TCEP Project No.: 097-039-15
LPS Bid No.: 8365

ADDENDUM NO. 1

Project:	LPS Humann Elementary Renovation
Project Number:	097-039-15
Meeting Date:	2/23/2016
Meeting Time:	4 PM
Meeting Location:	LPS Humann Elementary

EXISTING HANGING ACUSTIC PANEL DETAIL
 NOT TO SCALE
 FOR REFERENCE ONLY

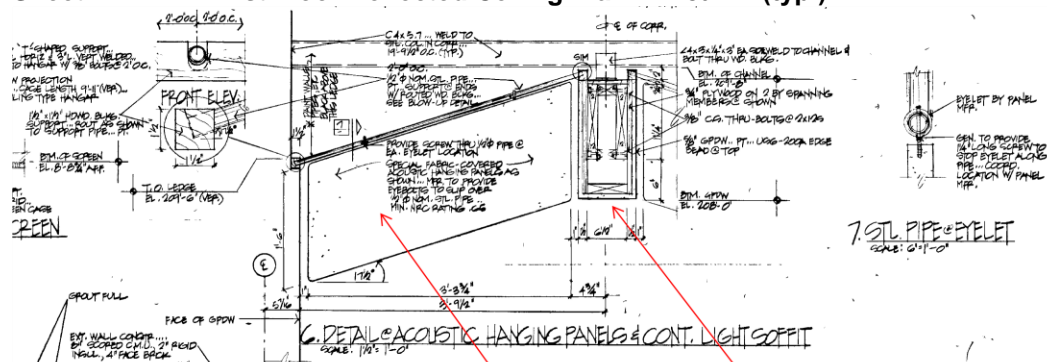
ON THE REFLECTED CEILING PLANS, REFER TO GENERAL NOTE 9:
 CONTRACTOR SHALL REMOVE ALL EXISTING BAFFLES / VERTICAL ACOUSTICAL PANELS IN MAIN CORRIDORS. BAFFLES SHALL BE STORED AND PROTECTED FOR REINSTALLATION. CONTRACTOR SHALL FIELD VERIFY SIZE AND QUANTITY OF BAFFLES TO BE STORED PRIOR TO REMOVAL. VACUUM CLEAN PRIOR TO INSTALLATION.

IT IS INTENDED THAT THE CENTER GYP.BD. SOFFIT IS TO REMAIN IN PLACE DURING CONSTRUCTION. AT THE CONTRACTOR'S DISCRETION, THE GYP.BD. SOFFIT MAY BE REMOVED AND REINSTALLED / RECONSTRUCTED TO FACILITATE OTHER CONSTRUCTION ACTIVITIES.

1	NON-BEARING WALL TYPICAL BRACING DETAIL
AD1-1	SCALE: 3/4" = 1'-0"

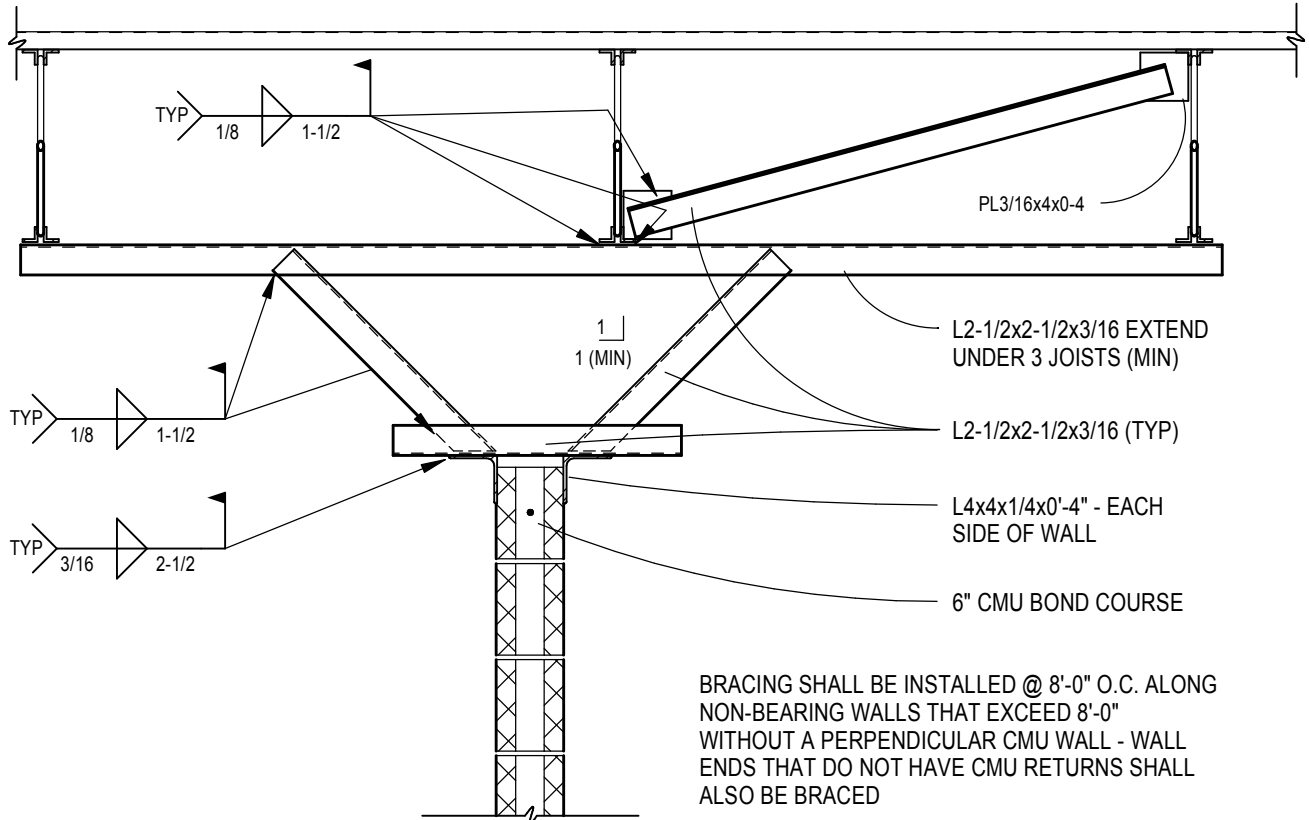
Refer to Masonry Partition Wall Types. Non-bearing CMU walls shall extend to one course above ceiling line, provide wall type H3 from top of CMU to structural deck and seal as noted. Refer to Non-Bearing Wall Typical Bracing detail, this detail is clarified by the attached Supplemental Drawing AD1-1.

Refer to Non-Bearing Wall Typical Bracing detail, this detail is clarified by the attached Supplemental Drawing AD1-1. On the construction documents, there is a cut mark referring to detail 15/S1.2, this is what the cut mark is referring to. Non-bearing CMU walls shall extend to one course above ceiling line, provide wall type H3 from top of CMU to structural deck and seal as noted.

ON THE CONSTRUCTION DOCUMENTS, THERE IS A CUT MARK REFERRING TO DETAIL '15/S1.2'. THE ABOVE DETAIL IS WHAT THE CUT MARK IS REFERRING TO.

PM1.07

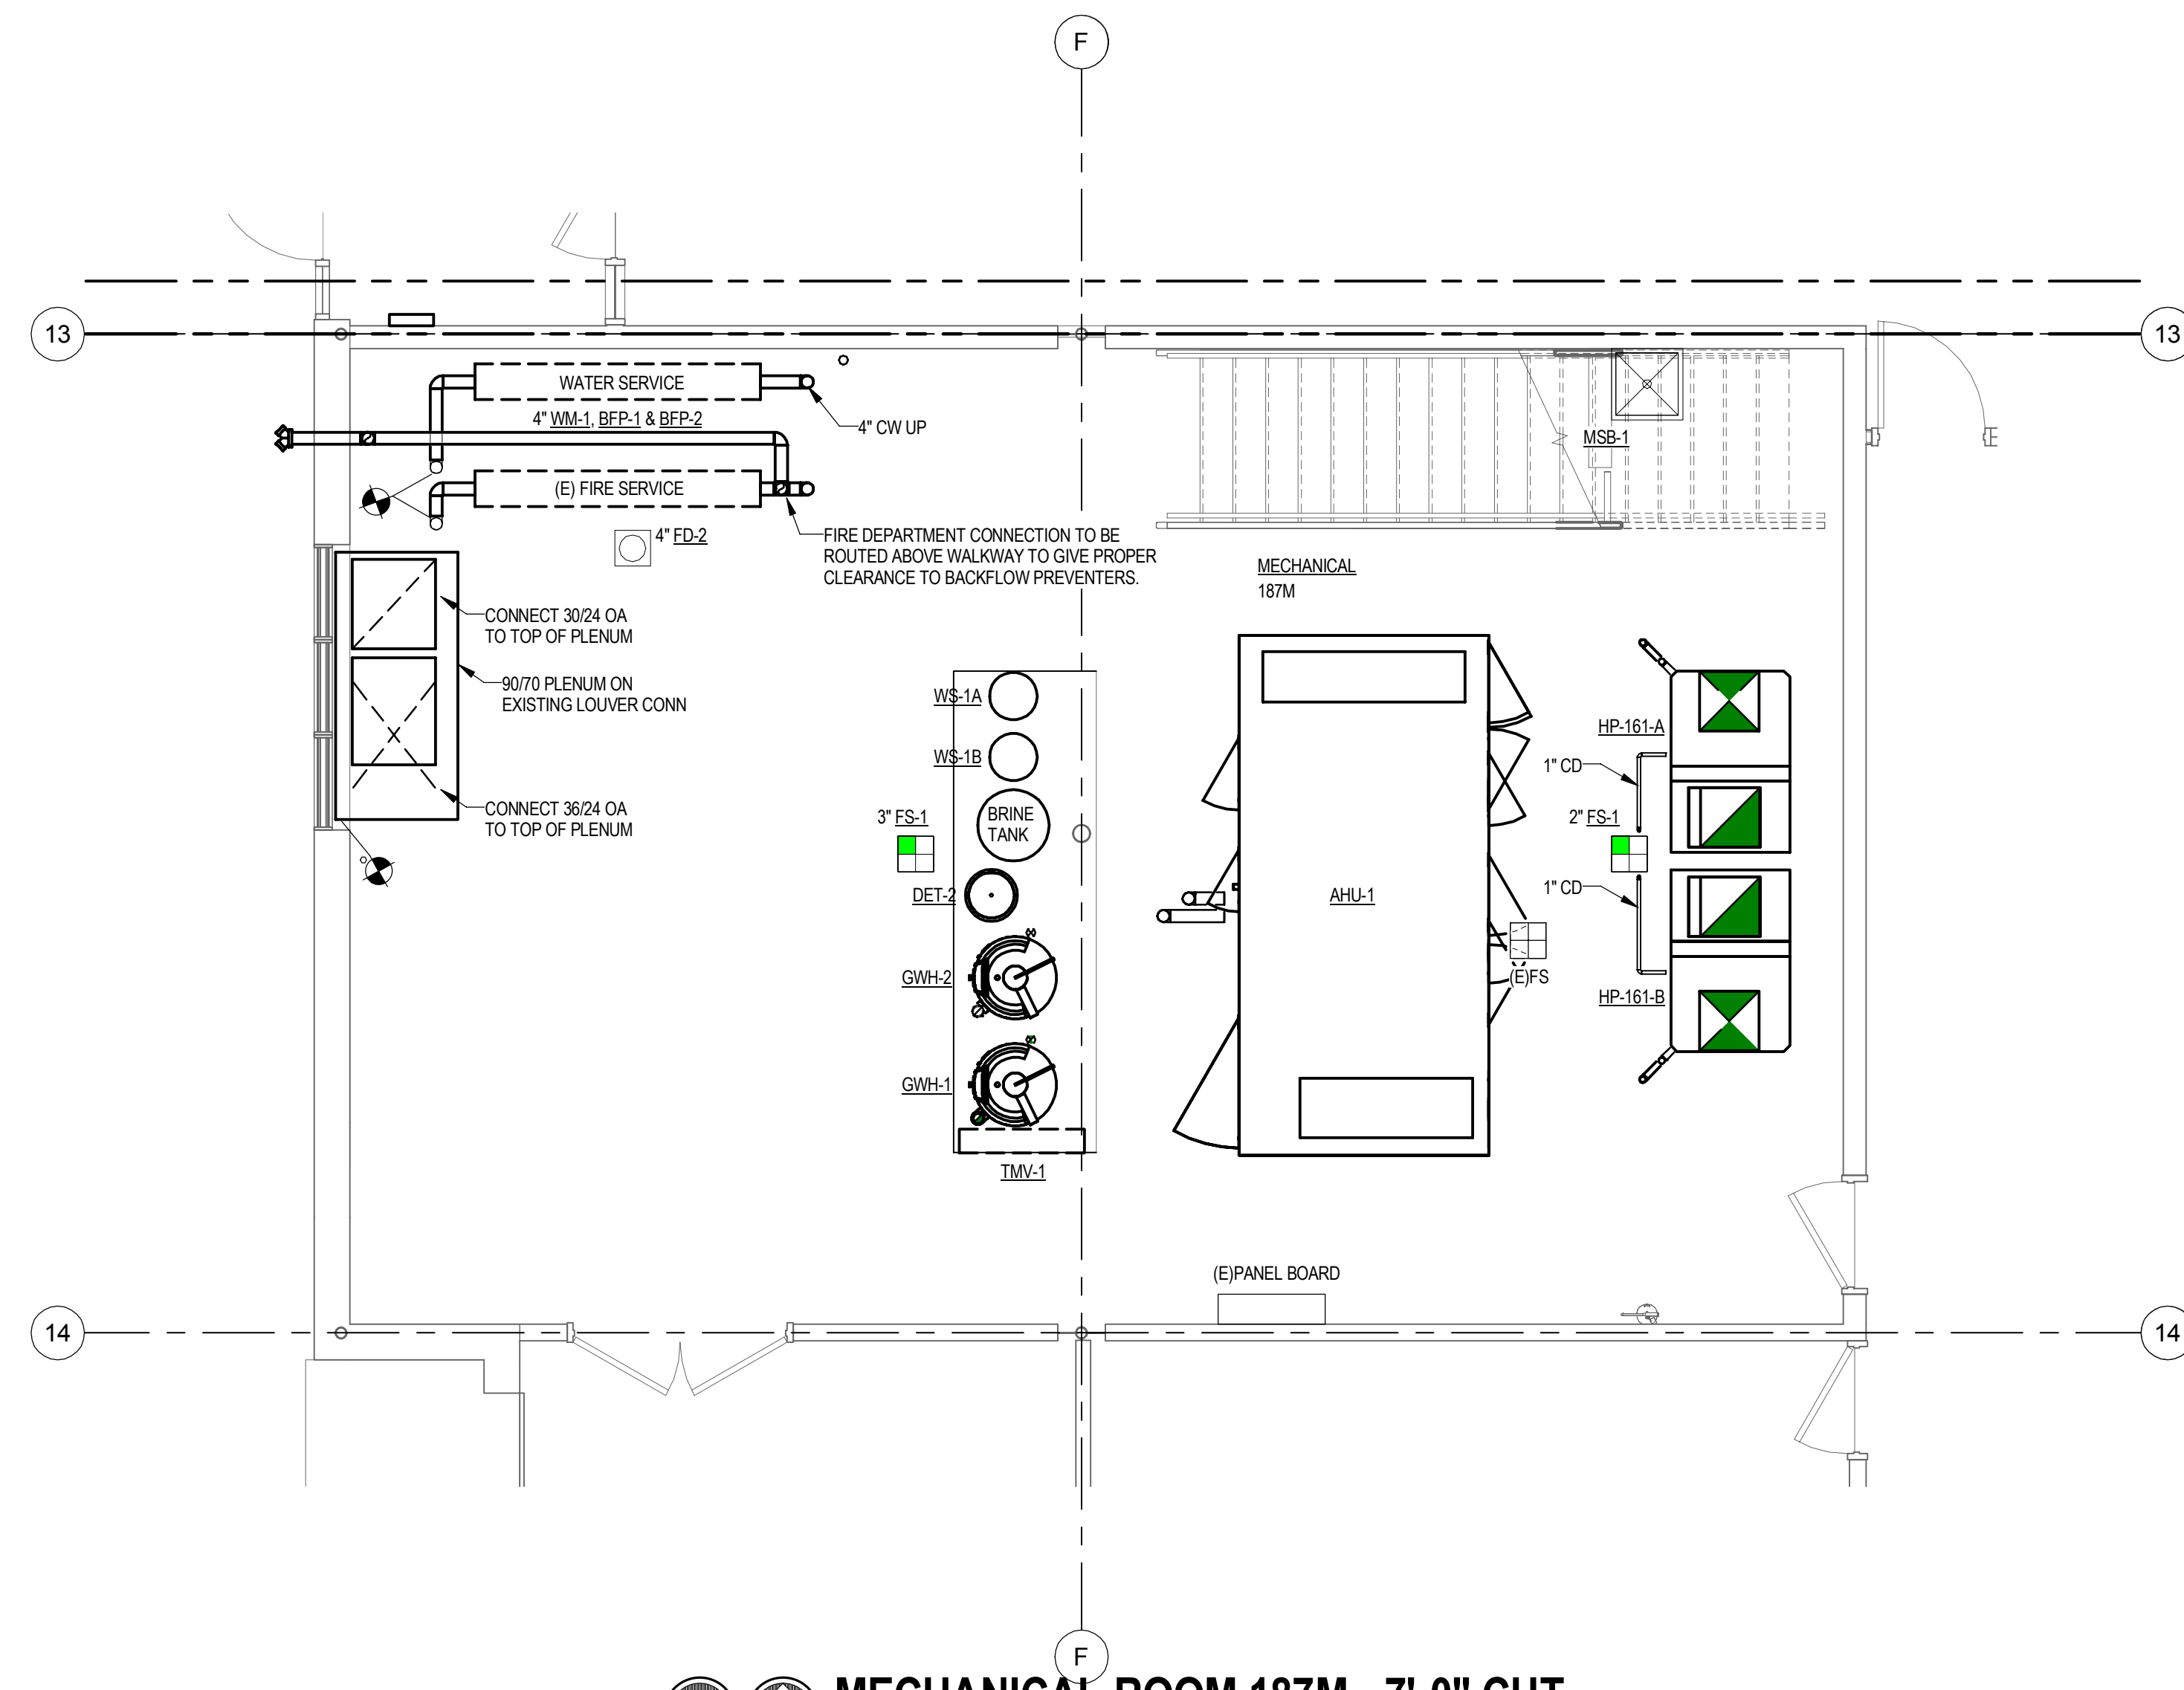
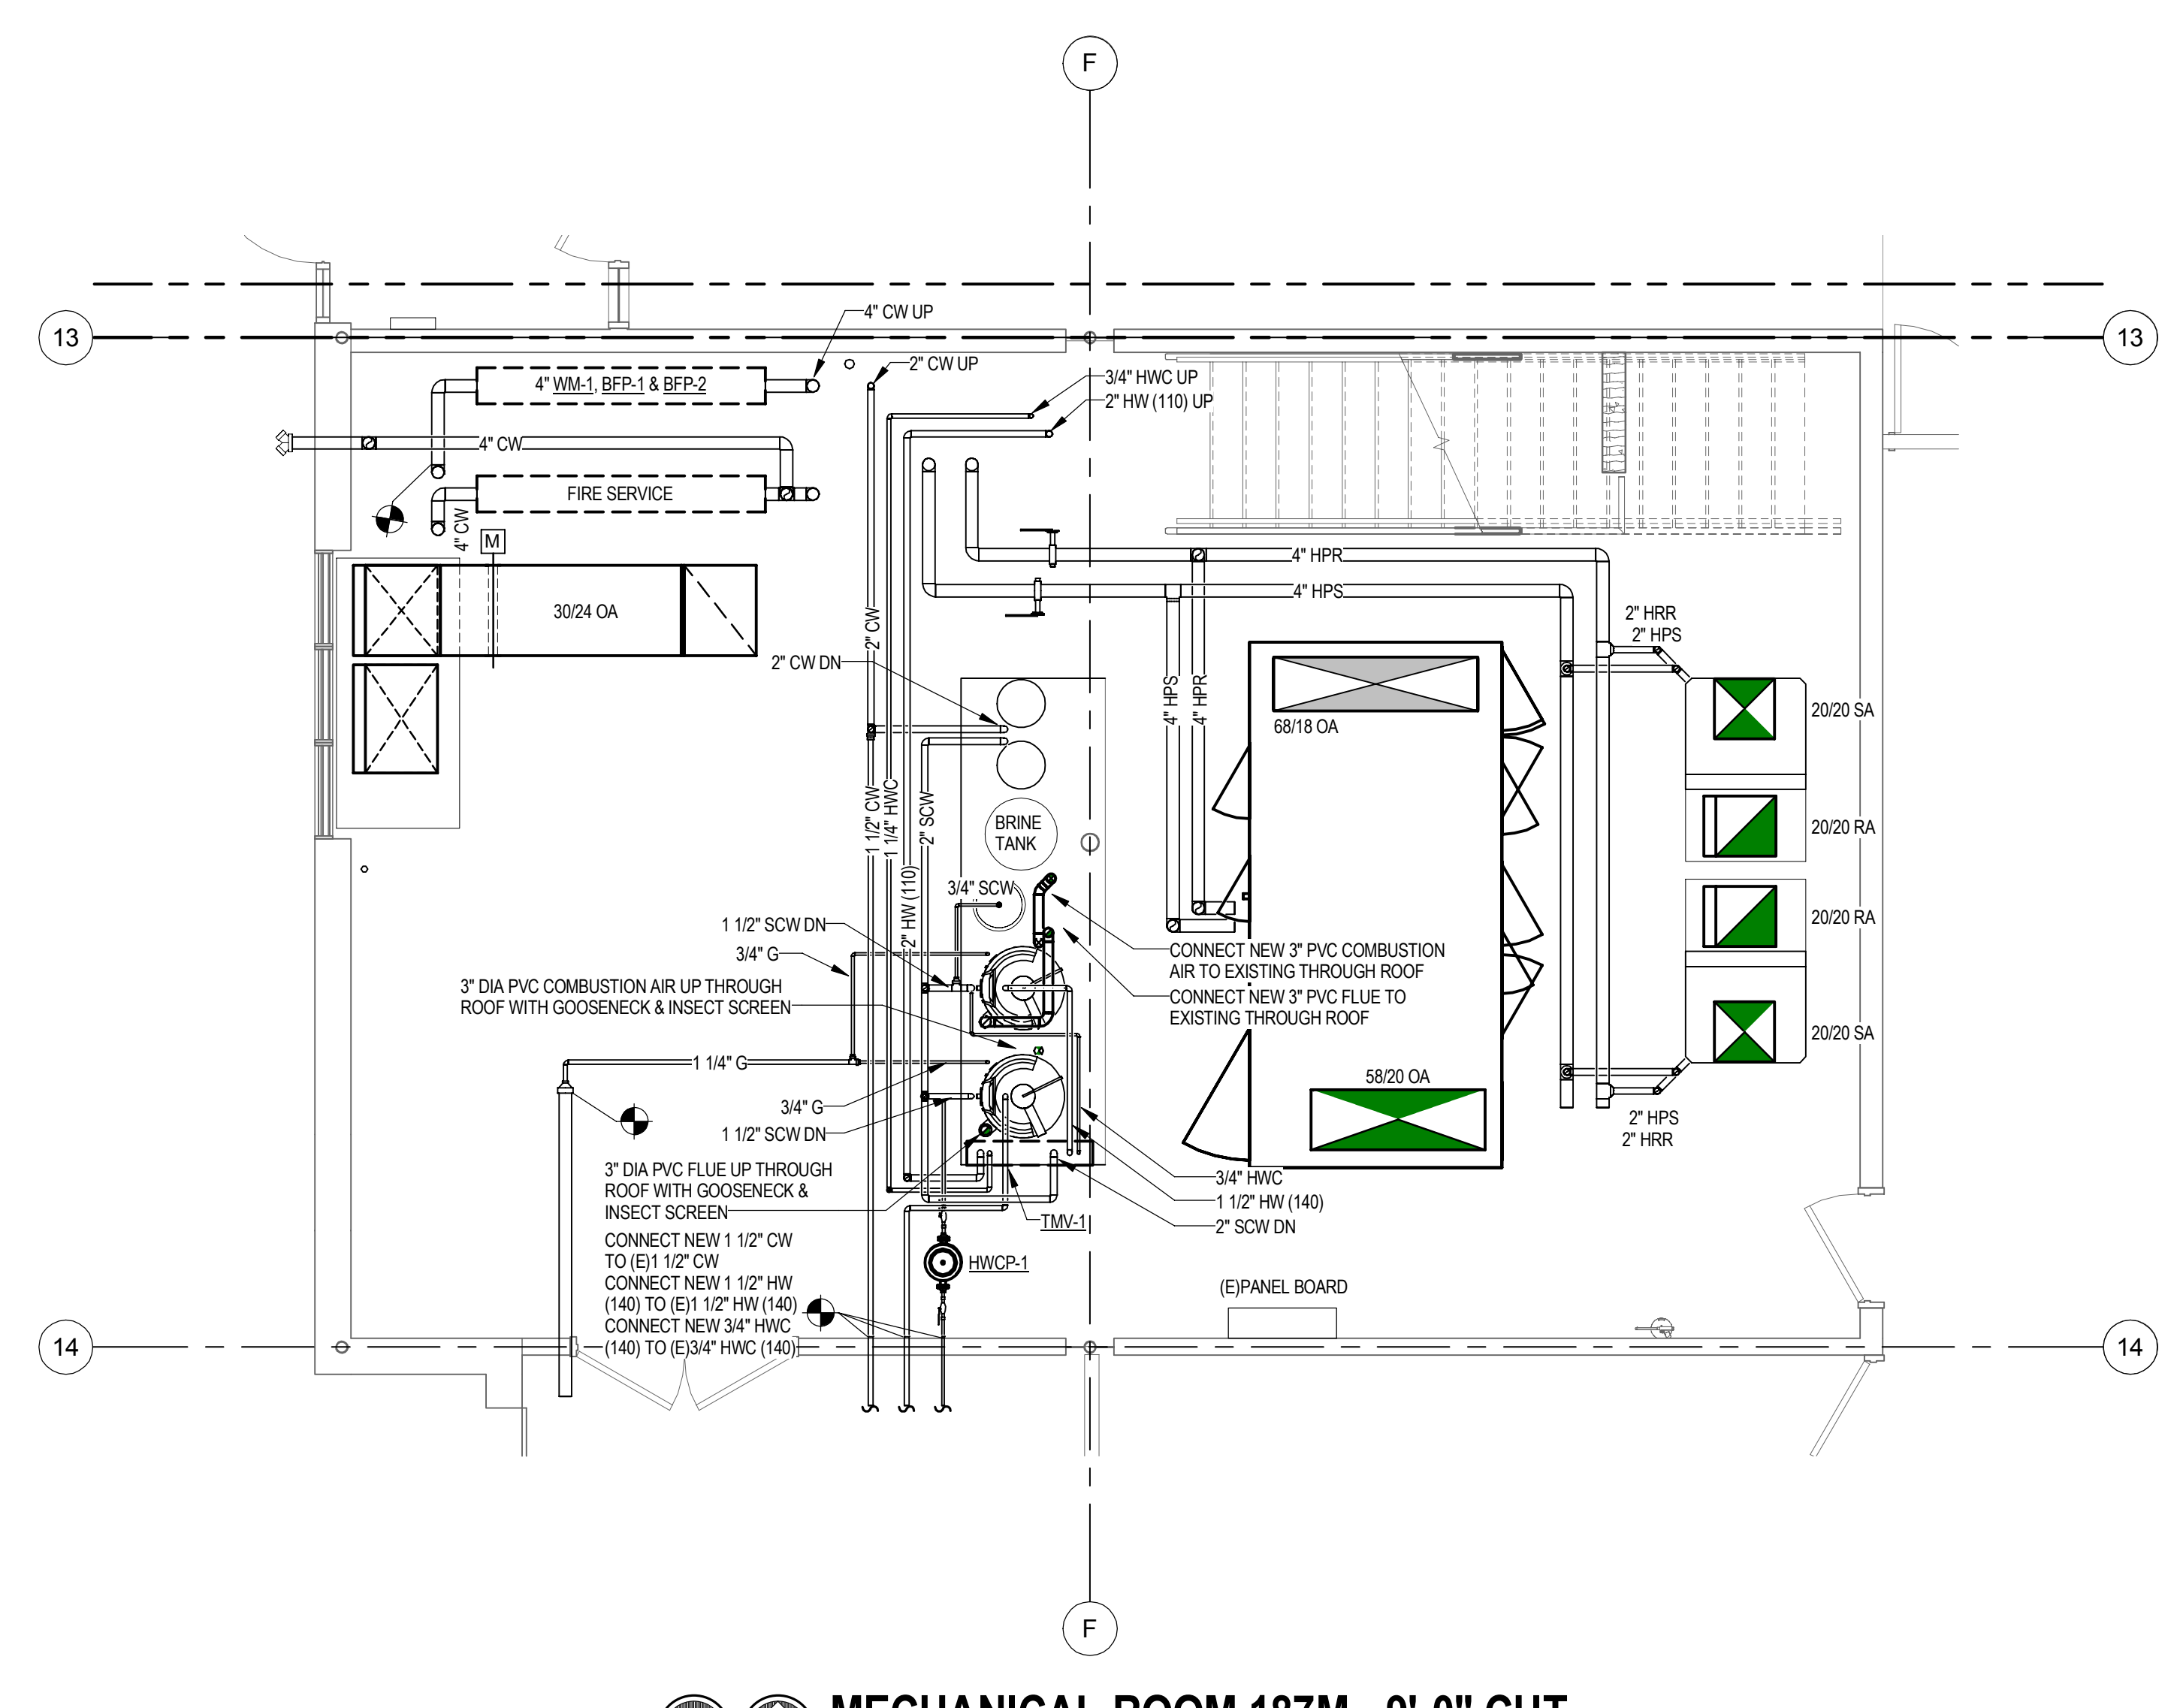
Sheet has been resubmitted showing new layout for AHU-1 unit.
